## Strategies for Monitoring the Performance of DNAPL Source Zone Remedies

August 2004

Prepared by  
The Interstate Technology & Regulatory Council  
Dense Nonaqueous-Phase Liquids Team

**Figure 2-1.** Conceptual Model of a DNAPL Source Within the Saturated Zone

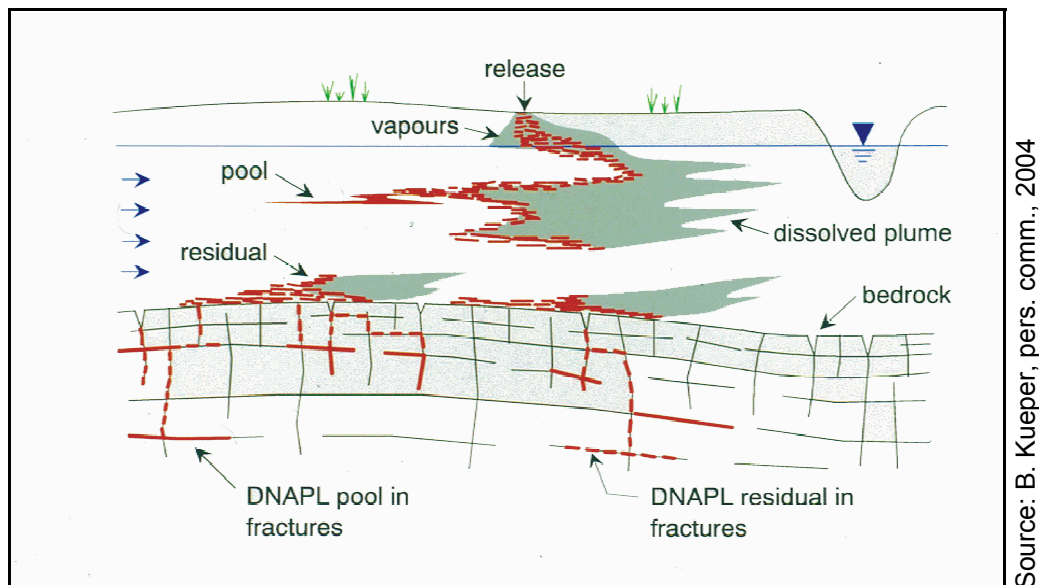
105. Figure 2-1, page 9: I am unable to differentiate between the two DNAPL zone/areas labeled "Pool" and "Residual" in the figure. If it's possible, please be sure that the labeled areas are not "questionable" areas that may fit both descriptions or if it may fit both, label it "Pool/Residual."

256. *On Figure 2-1 on Page 9, this figure should be modified to clearly illustrate the difference between residual and pooled DNAPL as defined in the text. The current illustration is unclear.*

**Figure 4-1.** Categories of Performance Metrics for DNAPL Zone Treatment

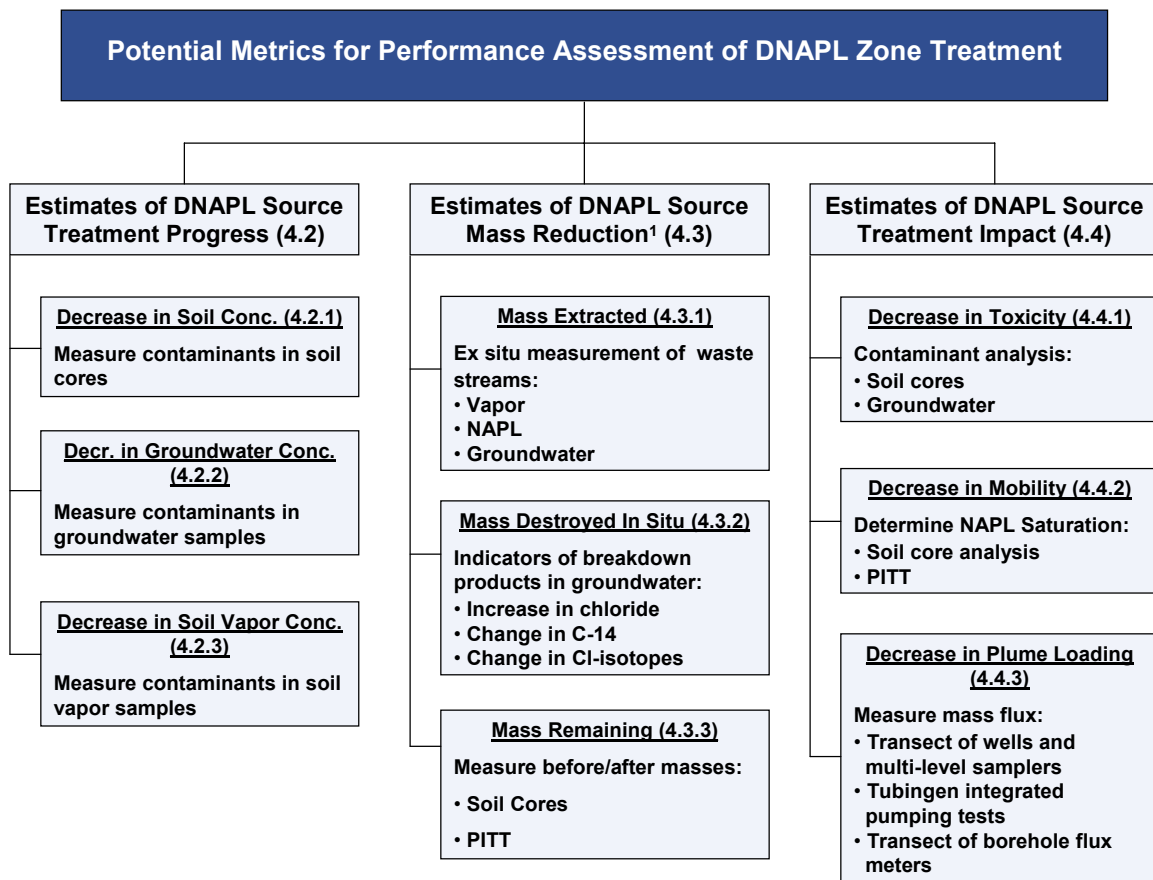
15. *Figure 4-1. Under “Decrease in Mobility” you might want to include reduced NAPL thickness in wells and reduced formation transmissivity to NAPL (e.g. bail down or low flow pumping tests)*

**Figure 4-2.** Concept of Mass Flux/Discharge and Source Strength

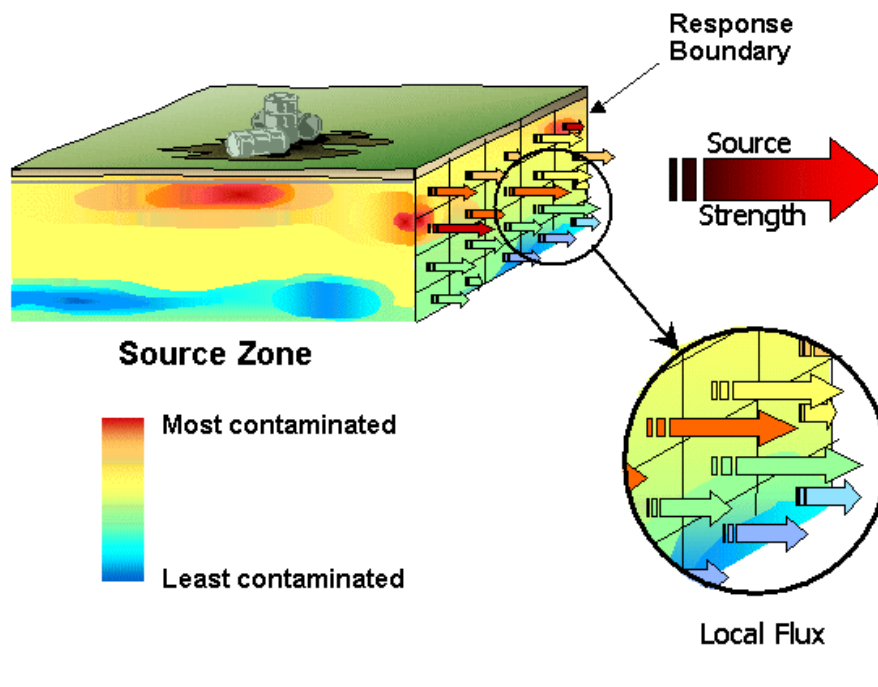
127. Figure 4-2, page 69: There are two large arrows with "Contaminant Flux (J)" -- there are two concerns: (1) it is difficult to determine if the symbol after the letter J is a comma or period or some other extraneous character and (2) the letter/variable "J" should be explained/introduced.

339. *Figure 4-2: Labels on large arrows should be changed from "Contaminant Flux" to "Contaminant Discharge".*

**Figure B6-1.** Kings Bay Phase I-III Results Showing Dissolved PCE Concentrations

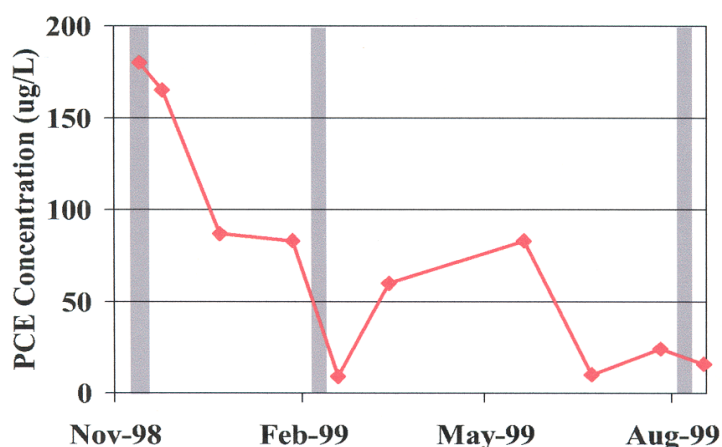
203. Case Study 6. This case study does not include any information about monitoring for temperature increases due to the high H<sub>2</sub>O<sub>2</sub> concentrations used, nor about the vapor monitoring results. Pg. B-34, 3<sup>rd</sup> paragraph - The PCE concentration is given as 9,000 "Fg/l". The units need to be corrected. Figure 1 - This figure only provides concentration data to August 1999; however, additional site characterization, oxidant injection, and/or monitoring occurred through 2002. It is recommended that the figure be replaced by one that provides the complete history of the concentrations at the site.
